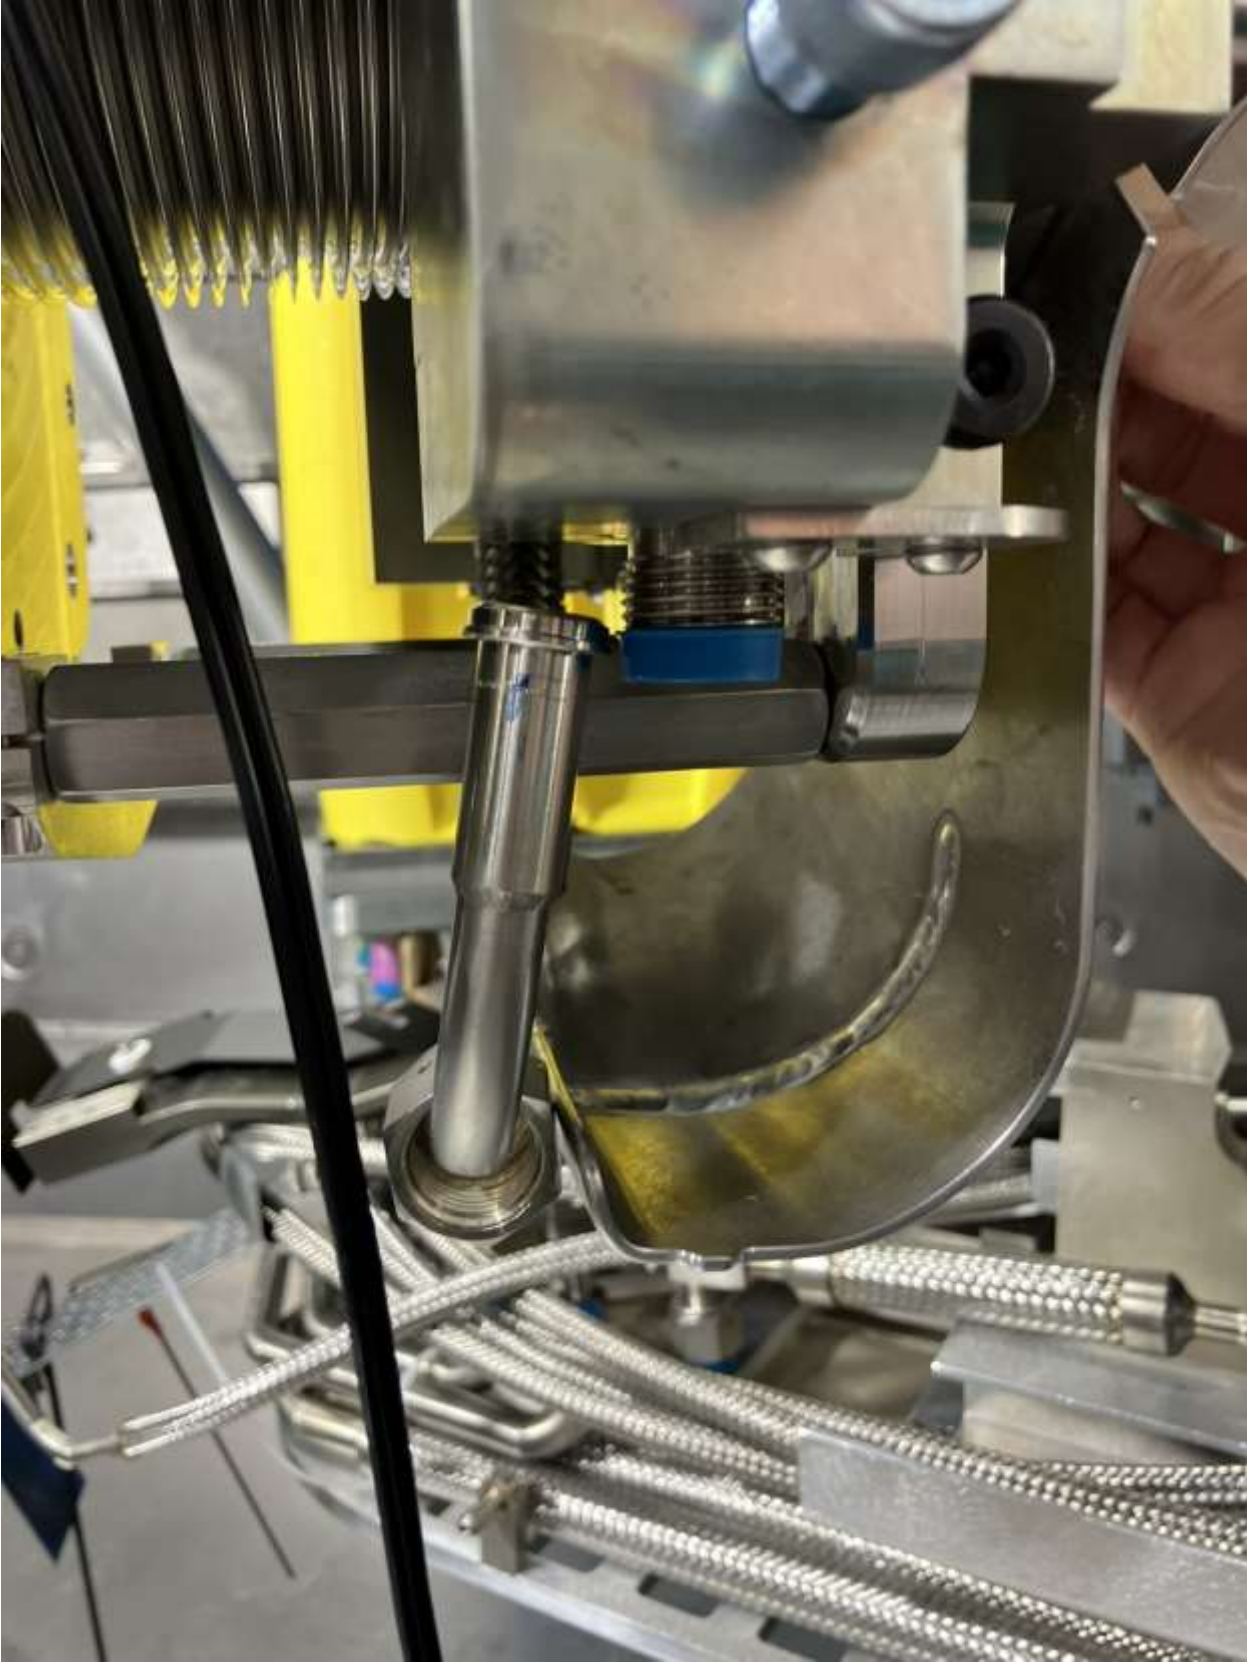
Torque tool interference when accessing HV shielding for this hanging VCR joint.

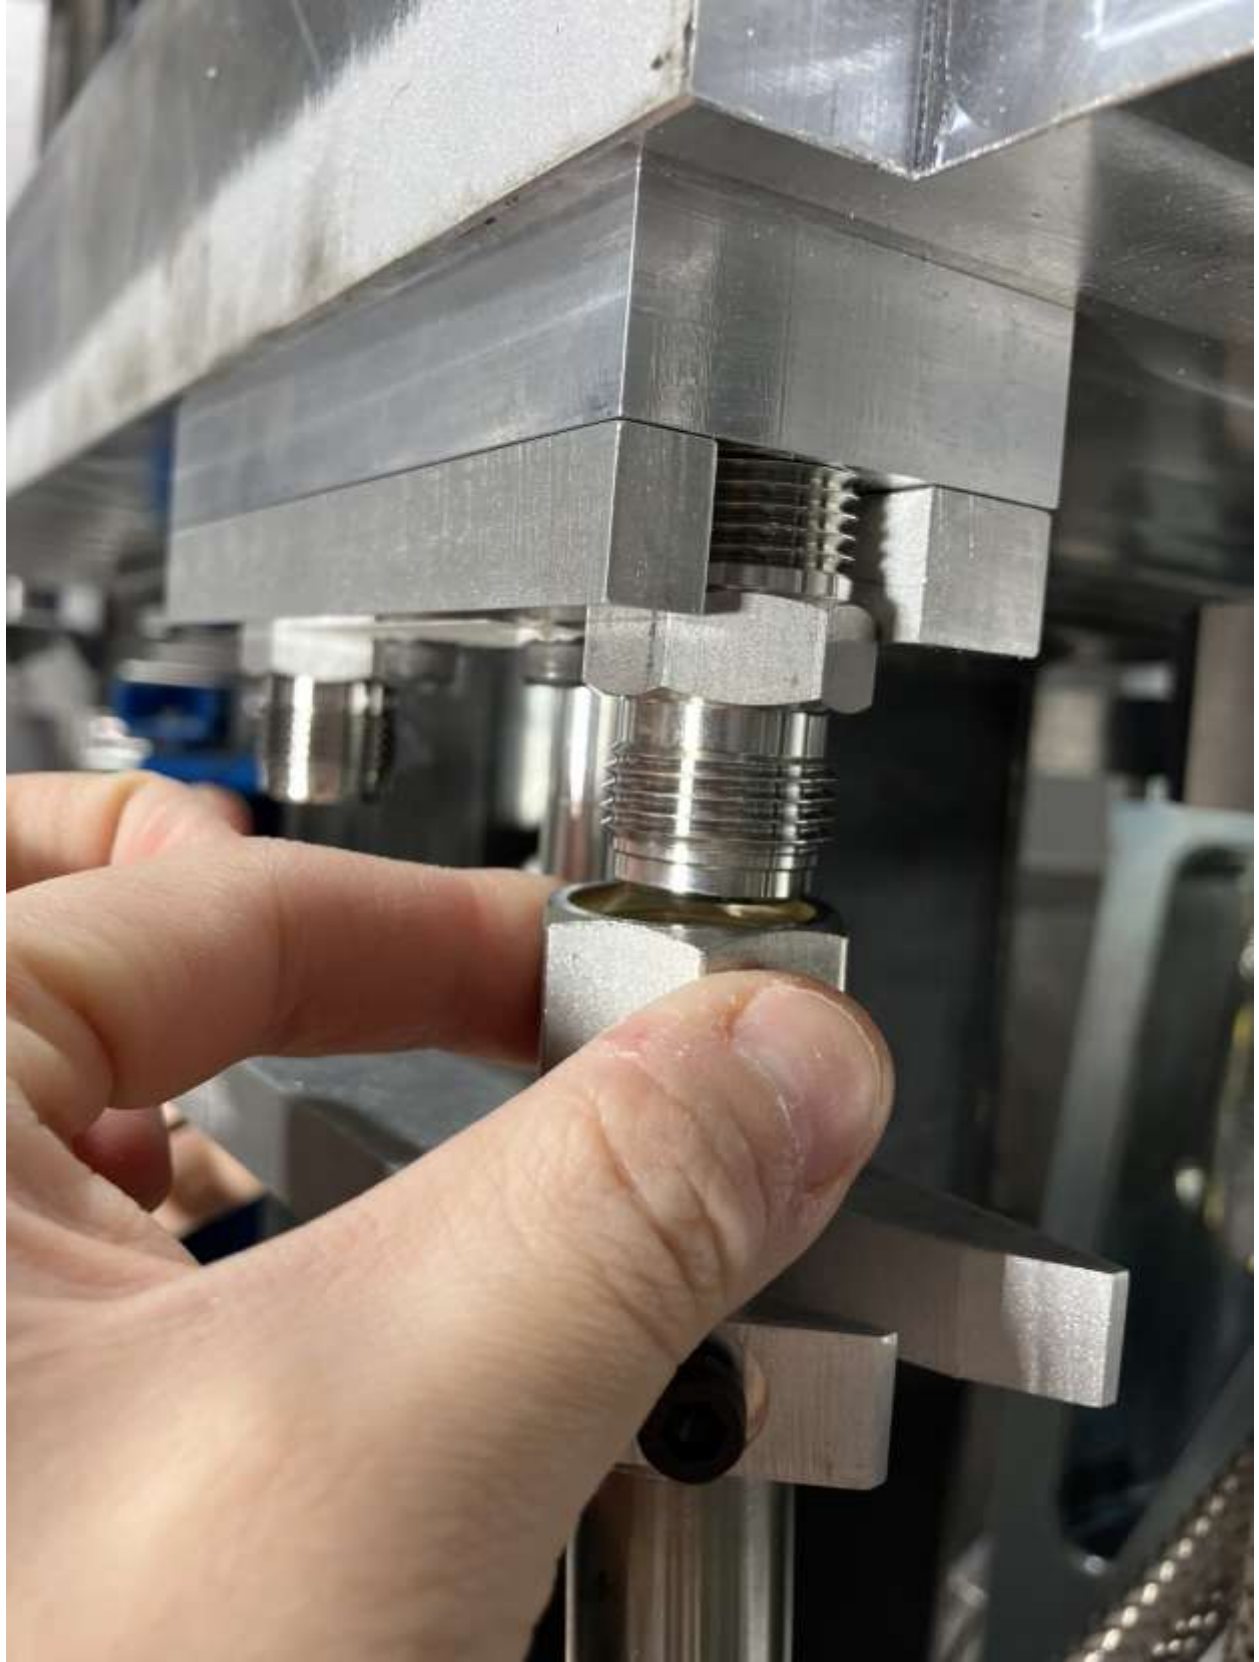
Bracket issue requires improper mounting of the female VCR side.

Successful positioning of the flexible lines on the upper driver side with manipulators into bracket.

Joint successfully re-done by hand, no need for manipulator testing.
